Model: Model C-P2c	Date: 17-Feb-05	No.: RG112001a
--------------------	-----------------	----------------

Subject: Controller Firmware Release History (System)		Prepared by: A. Ishiyama	
From: 1st Tech. Support Sec. Service Support Dept.			
Classification:	<input type="checkbox"/> Troubleshooting	<input type="checkbox"/> Part information	<input type="checkbox"/> Action required
	<input type="checkbox"/> Mechanical	<input type="checkbox"/> Electrical	<input type="checkbox"/> Service manual revision
	<input type="checkbox"/> Paper path	<input type="checkbox"/> Transmit/receive	<input type="checkbox"/> Retrofit information
	<input checked="" type="checkbox"/> Other ()

Model: Model C-P2		Date: 25-Mar-05	No.: RG112009
Subject: Bypass Tray Paper Pick-up Mechanism		Prepared by: A. Ishiyama	
From: 1st Tech. Support Sec. Service Support Dept.			
Classification:	<input type="checkbox"/> Troubleshooting	<input type="checkbox"/> Part information	<input type="checkbox"/> Action required
	<input checked="" type="checkbox"/> Mechanical	<input type="checkbox"/> Electrical	<input type="checkbox"/> Service manual revision
	<input type="checkbox"/> Paper path	<input type="checkbox"/> Transmit/recei

Important Note on the Bypass Feed Mechanism

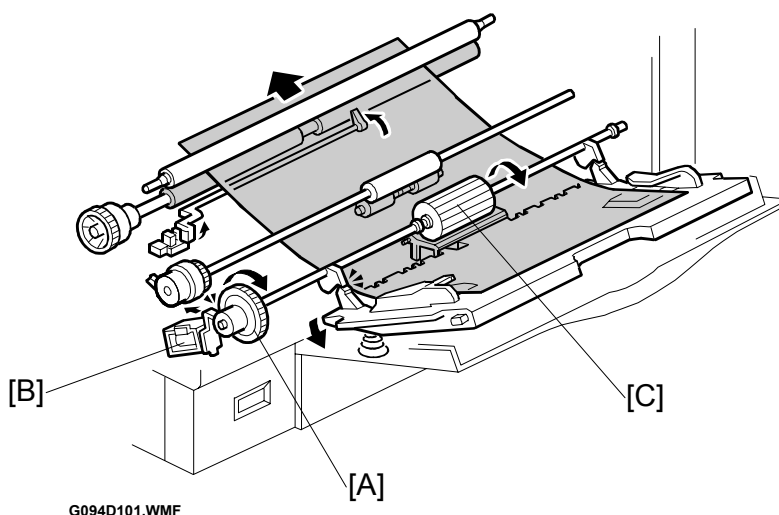
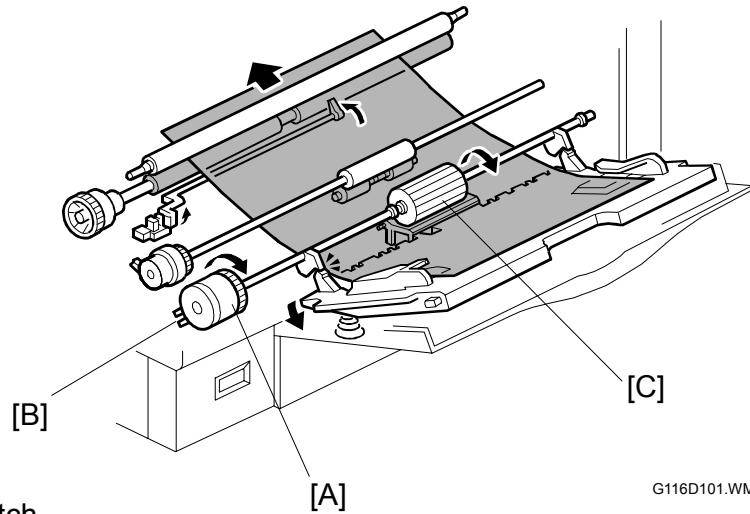
The paper feed mechanism for the bypass tray will be **temporarily** changed from a clutch system to a **solenoid** system. The system will be changed back to the clutch system from around August 2005 production (cut-in S/N TBA).

- This is the same solenoid system that is used on the C-P1/K-P3.
- This change is for the C-P2b/P2c and K-P4.
- See MB MG112003 for the P/N details.

Solenoid System: Same as the C-P1/K-P3 system

Clutch System: Originally designed for the C-P2/K-P4

5.4.3 MACHINE FIRMWARE [G113/G116]

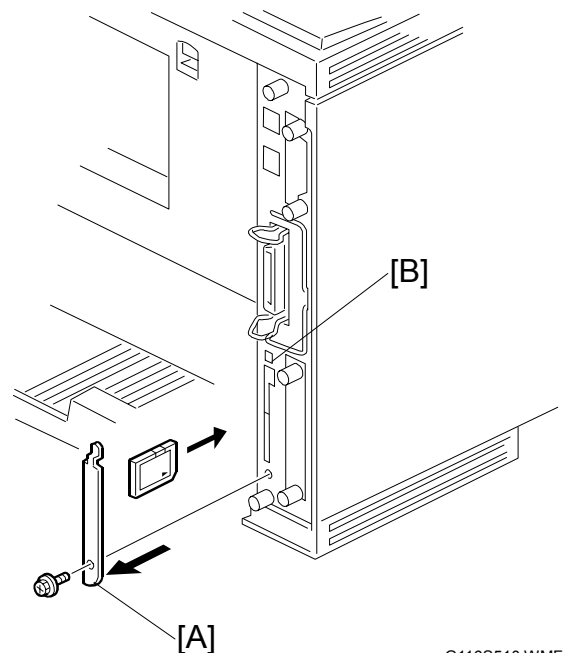
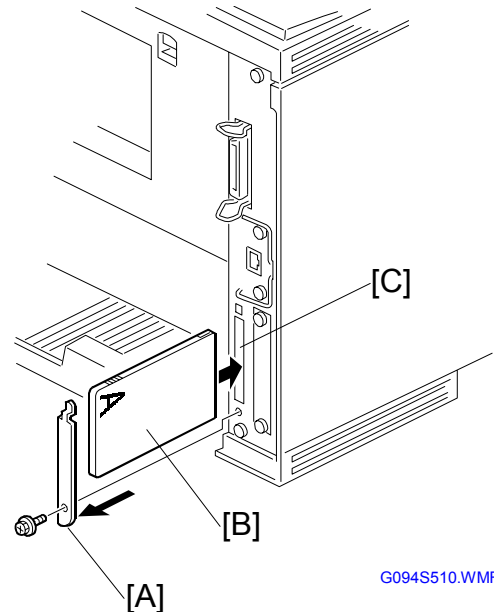
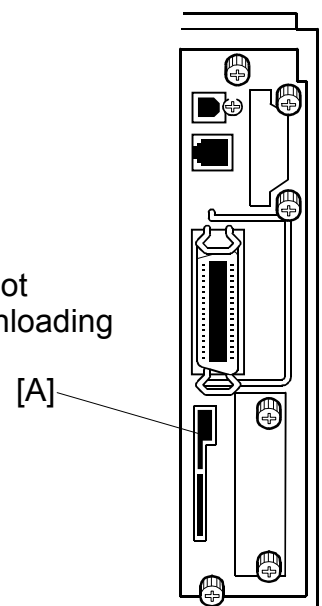
The Service Manual was corrected as follows:

Some sections for the C-P2b (G112) were added to the Service Manual for the G112/G113/G116.

- The corrections are in blue.
- Reason: An IC card is used to update the firmware on the G112. This information was missing from the Service Manual.
